Voltage Regulators

Title <b>Filter/Regulator Board 4</b>		
Size B	Number	Revision <b>1.1</b>
Date: 9/8/2020	Sheet 1 of 1	
File: C:\Bob\Filter_Regulator_Bd4.SchDoc	Drawn By: Bob Harbour

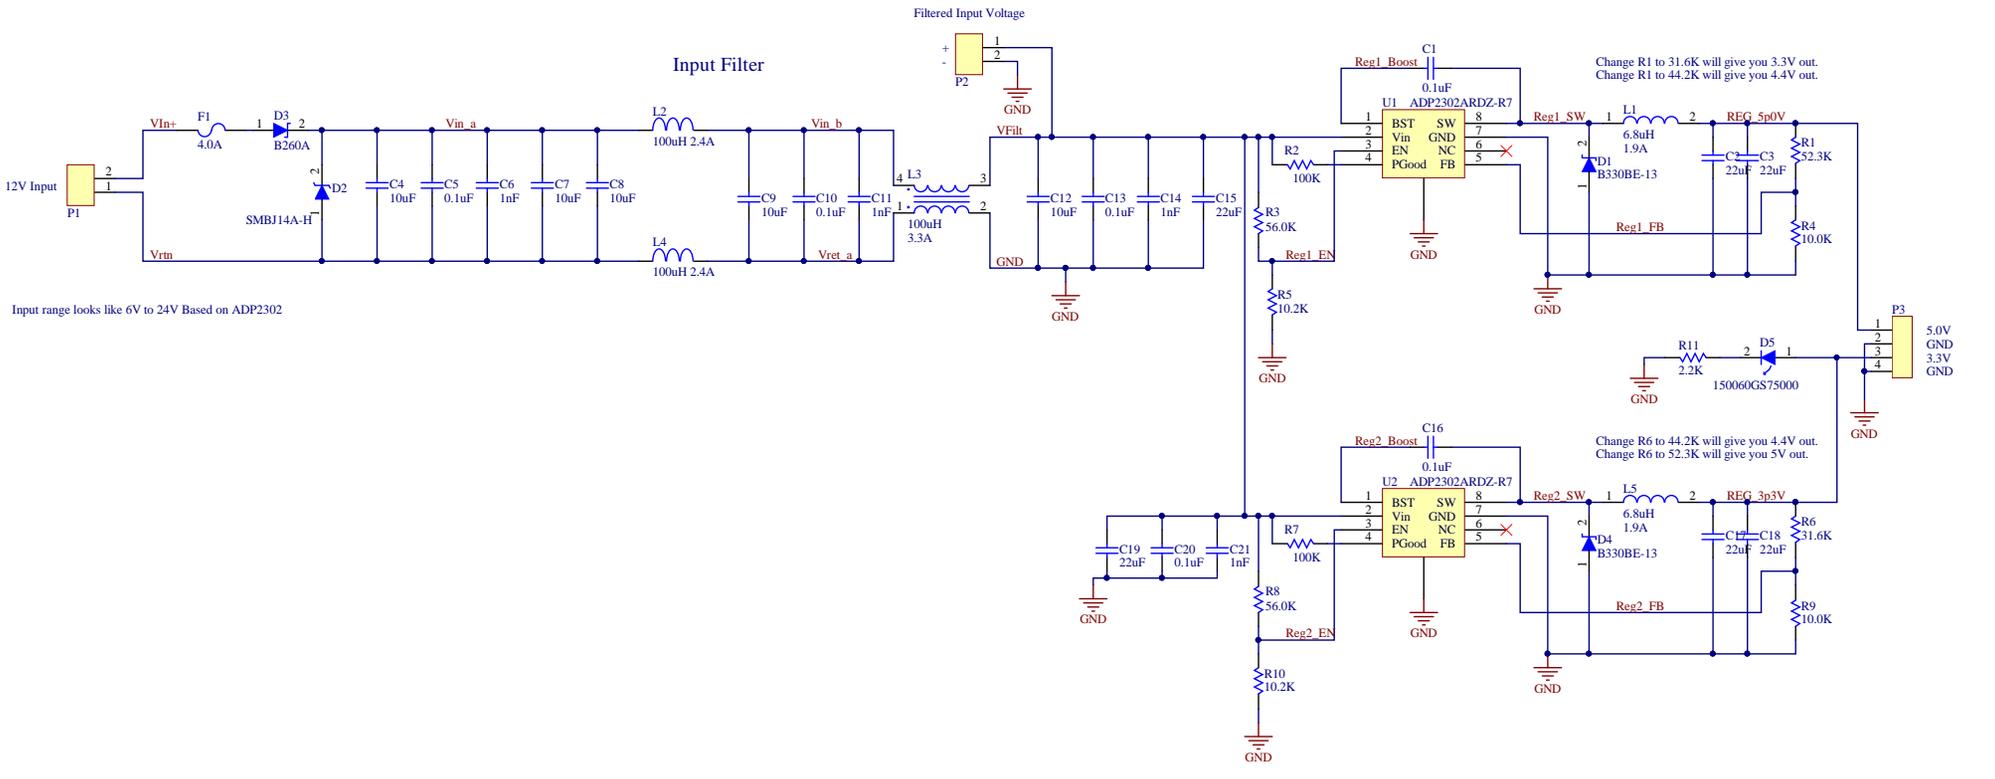
Input range looks like 6V to 24V Based on ADP2302

Change R1 to 31.6K will give you 3.3V out.  
Change R1 to 44.2K will give you 4.4V out.

Change R6 to 44.2K will give you 4.4V out.  
Change R6 to 52.3K will give you 5V out.

R1.1 8/8/2020 Replace L2, L3, L4 with higher current inductors.
